APPLICATION NO.	FILING DATE	FIRST NAMED INVENTOR	ATTORNEY DOCKET NO.	CONFIRMATION NO.
10/594,709	12/06/2006	Heiner Kudrus	KUDRUS-2 PCT	3651
25889	7590	04/22/2008		
COLLARD & ROE, P.C. 1077 NORTHERN BOULEVARD ROSLYN, NY 11576			EXAMINER SINGH, KAVEL	
			ART UNIT	PAPER NUMBER
			3651	
			MAIL DATE	DELIVERY MODE
			04/22/2008	PAPER

Office Action Summary	Application No. 10/594,709	Applicant(s) KUDRUS, HEINER	
	Examiner KAVEL P. SINGH	Art Unit 3651

DETAILED ACTION

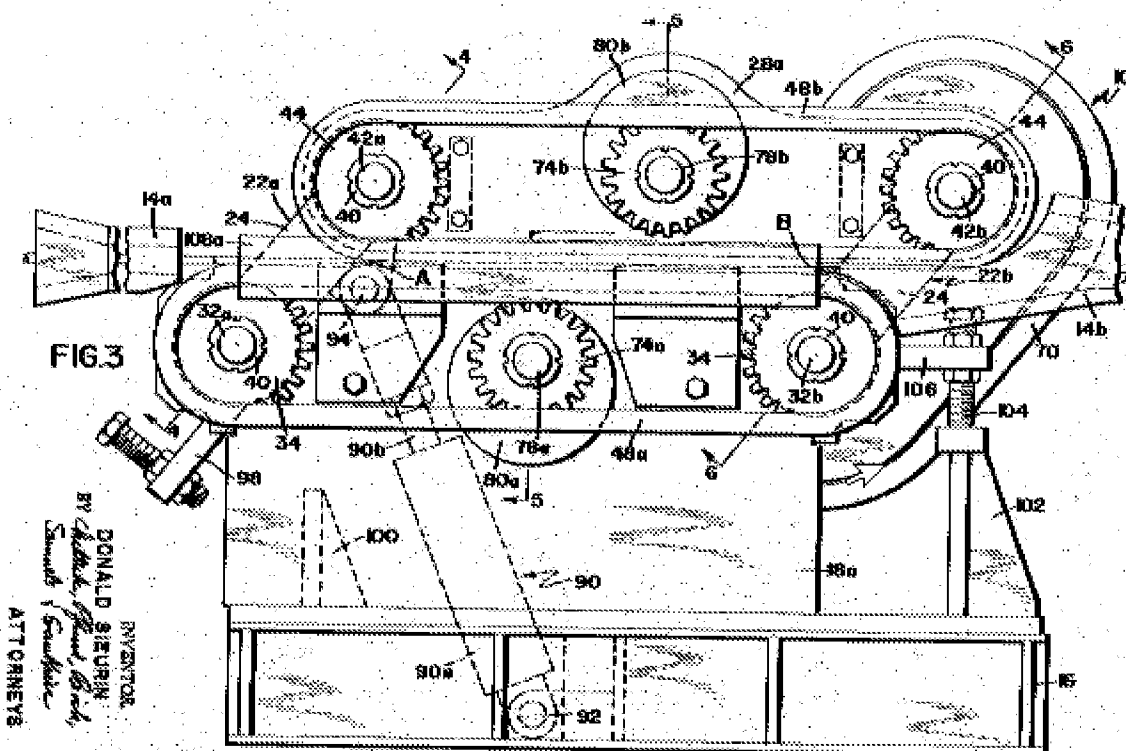
Applicant's arguments filed 12/19/07 have been fully considered but they are not persuasive. Applicant argues that Sieurin does not teach the first half frame and the second half frame are not disposed on the first and second sides of the drawing plane. The Applicant's depiction of the first (18) and second sides (20) is shown in Figure 1:

Applicant is arguing that from Figure 4 of the Sieurin reference, does not show first and second sides (which is a sectional view of Figure 3 through sprockets 32a), but Applicant failed to look at figure 3, which is shown below:

The first and second sides are on the opposite sides of the material being conveyed (14), not shown, but described in C2 L46-50. Applicant then argues that Sieurin does not teach first or second frame halves, but as shown in Figure 4 (18a,18b,28a,28b). For the foregoing reasons, claims 1-30 stand rejected.
